SUBJECT: COOPER NUCLEAR STATION - AMENDMENT NO. 123 TO FACILITY
OPERATING LICENSE NO. DPR-46 (TAC NO. 68043)

The amendment changes the Technical Specifications for the Standby Liquid Control System to reflect 10 CFR 50.62 Anticipated Transient Without Scram (ATWS) modifications.

SAFETY EVALUATION BY THE OFFICE OF NUCLEAR REACTOR REGULATION
RELATED TO AMENDMENT NO. 123 TO FACILITY OPERATING LICENSE NO. DPR-46
NEBRASKA PUBLIC POWER DISTRICT
COOPER NUCLEAR STATION
DOCKET NO. 50-298

FIGURE 3.4.1

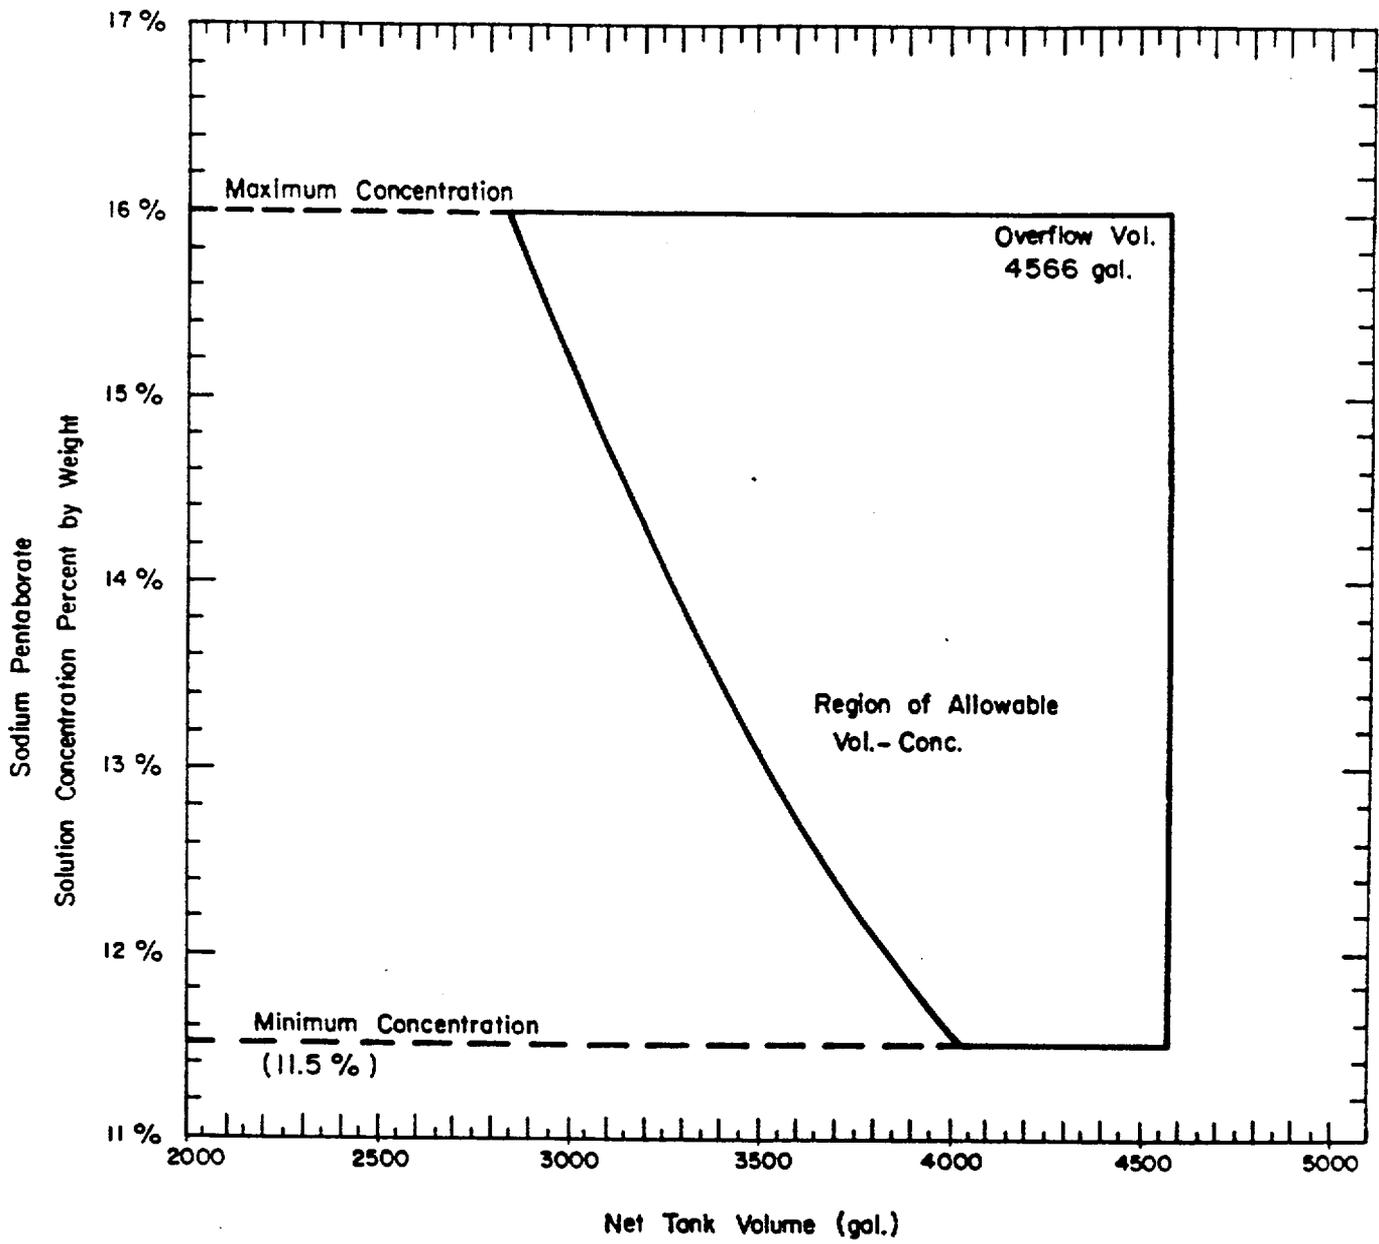
- (1) Revise SLCS pump discharge pressure relief valve settings to raise the minimum opening pressure from 1400 psig to 1450 psig, and raise the minimum reset pressure from 1215 psig to 1300 psig,
- (2) Revise the monthly flow rate surveillance test to clarify that pump suction is to be from the "Standby Liquid Control Storage Tank" during the test, and
- (3) Revise the SLCS Tank volume vs. sodium pentaborate concentration limits figure.

Storage Tank Volume-Concentration Limits

The volume-concentration envelope of the figure would be revised to specify the new minimum concentration limit (11.5%) which will ensure that the system meets both the new requirements and the original system design basis. The new limits were previously evaluated and determined to be acceptable. The amendment will implement the requirement and is acceptable. It is noted that the licensee proposes to delete Storage Tank level alarm setpoint data from the figure. Since there are no Limiting Conditions for Operation or Surveillance Requirements associated with the level alarms such information need not be included on the figure. This is consistent with the guidance of the Standard Technical Specifications (NUREG-0123) and is acceptable.

A minimum quantity of 2840 gallons of solution having a 16.0 percent sodium pentaborate concentration, or the equivalent as shown in Figure 3.4.1, is required to meet this shutdown requirement.
